ADDENDUM NO. 01

PROJECT TITLE: Giraffe Shade/Feeding
Structure – Peoria Zoo #25-065

ISSUANCE DATE: 08.08.25

MODEL
DLB1200A/DLB1205A
1200lb/544kg CAPACITY
BRAKE WINCH

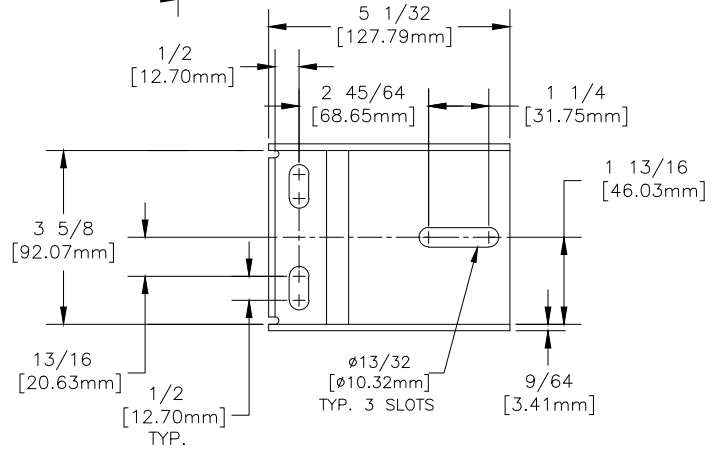
- a. Reference Sheet A1 and A2 – Change all original bid drawing references of winch model to DLB 1200A PLATED (2 total) in lieu of originally specified winch. See attached included manufacturer's product data sheets and instructions. The wire rope size shall be 7/32" dia. and 60 feet in length. A removable handle DLB Series winch handle 7" shall be provided as well for each winch (2 total) (part#14467). A 6456 DLB Series Brake Winch Drill Drive Socket (part#14466) shall be provided for each winch (2 total).
- b. Reference Sheet A2: Replace winch data sheets and instructions with the attached new manufacturer's data sheets for the DLB1200A winch.
